U.S. Department Of Transportation Federal Highway Administration

August 13, 1993

Refer to: HNG-14/SS-37

TYP. WALL THICKNESS: 0.160 in. .67 in. 3.75 in. CGD1 66 in.

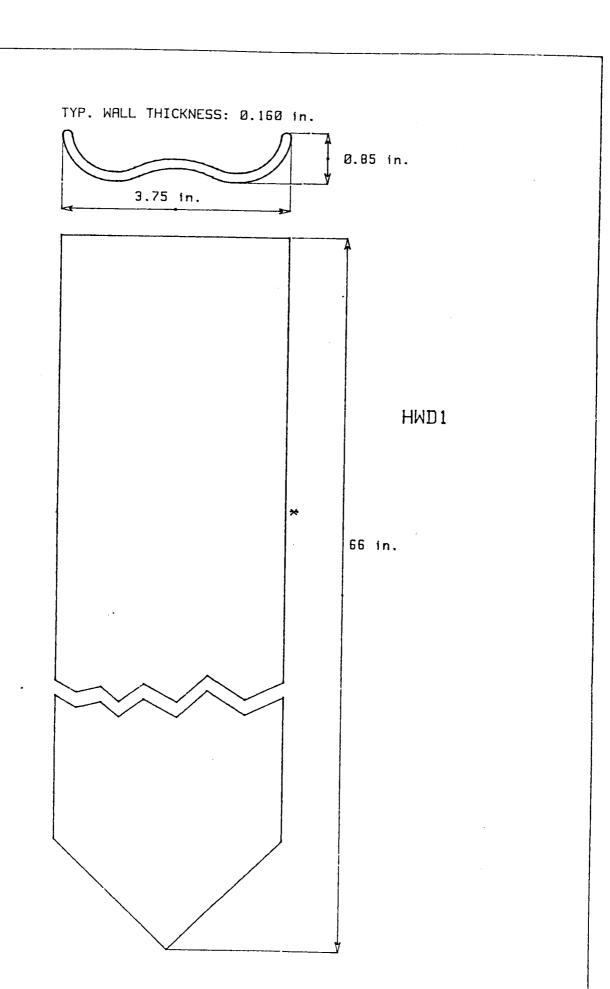
Based upon the test data you supplied we can infer compliance with the intent of the NCHRP Report 350. It is apparent that your company's posts had very little effect on the velocity, stability, or integrity of the impacting vehicle. Therefore, GreenLine Corner Guard posts and GreenLine Highway Delineator posts may be used on National Highway System projects, if required by a State.

Our acceptance is limited to yielding characteristics of the Greenline delineator post and does not cover their structural features. Presumably, you will supply potential users with sufficient information on structural design and installation requirements to ensure proper performance. We anticipate that highway agencies will require certification from you that the hardware furnished will have essentially the same composition, mechanical properties, and geometry as those of the tested posts upon which our acceptance is based.
